The Keadby Next Generation Power Station Project

Document Ref: 8.7

Applicant's Responses to Action Points for Deadline 2 (submitted at Deadline 2)

SHEET TITLE
 TREE PROTECTION PLAN (SHEET 08)

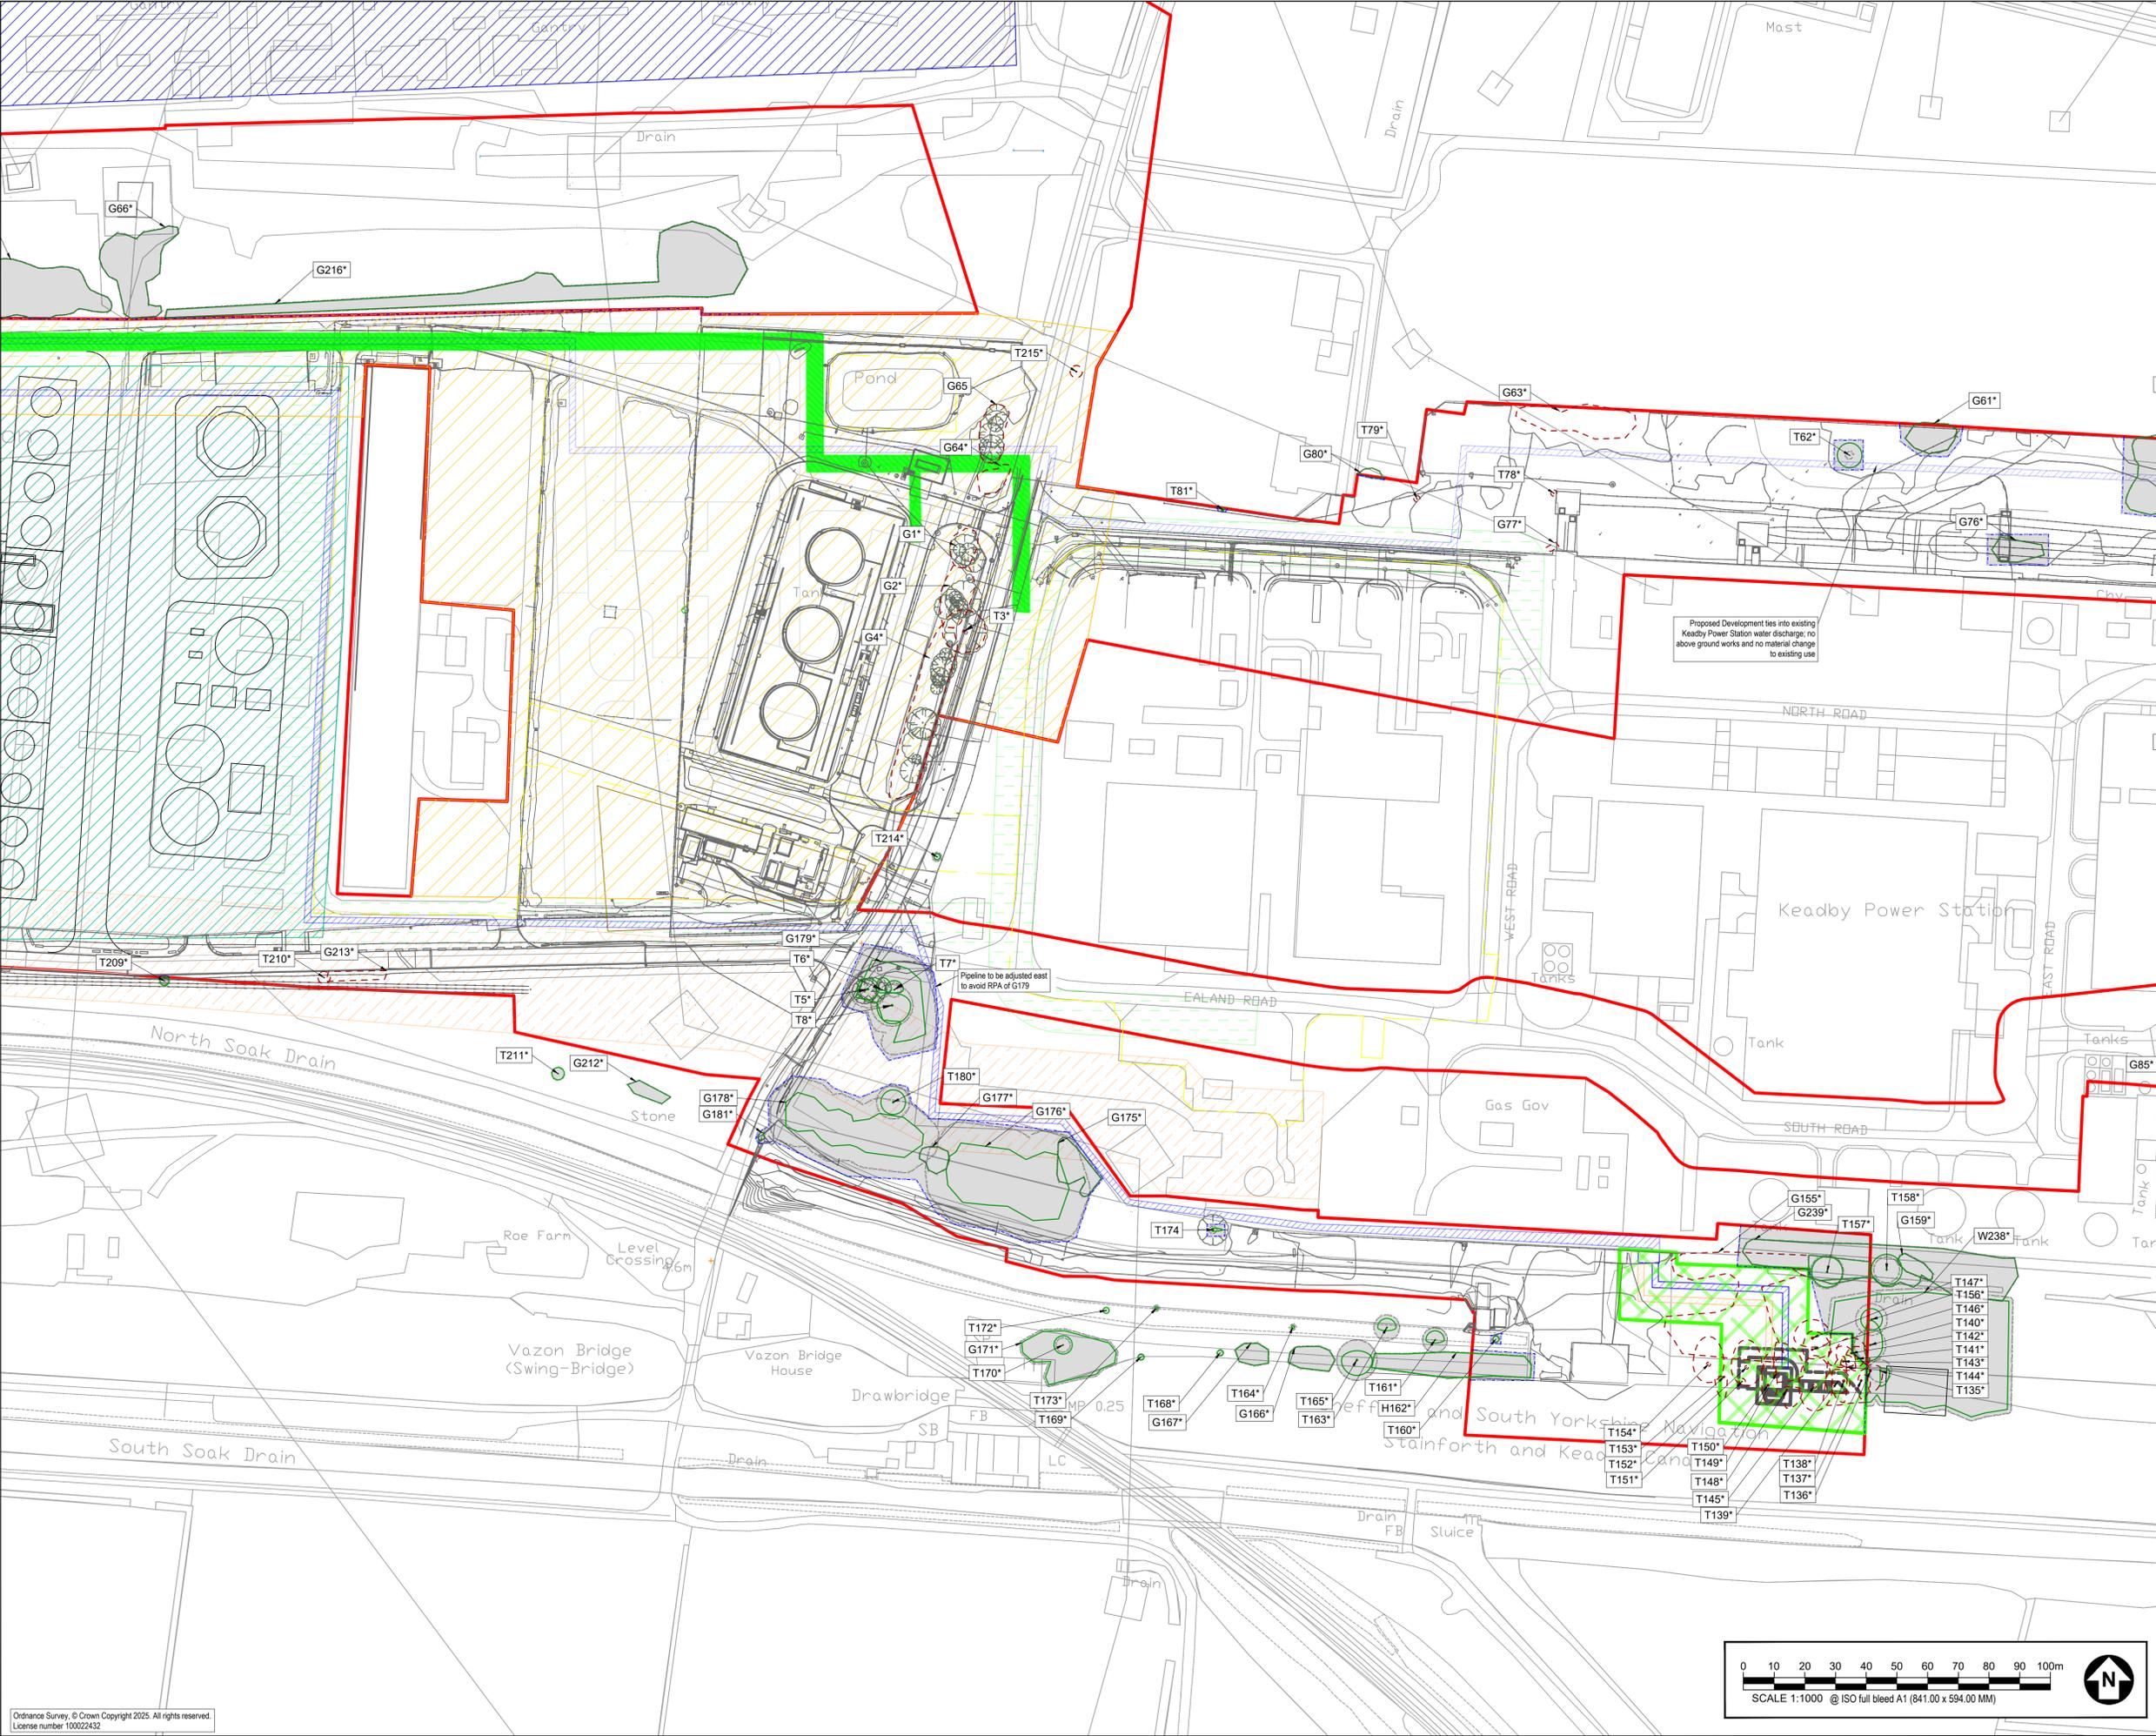
Pipeline to be adjusted east to avoid RPA of G179
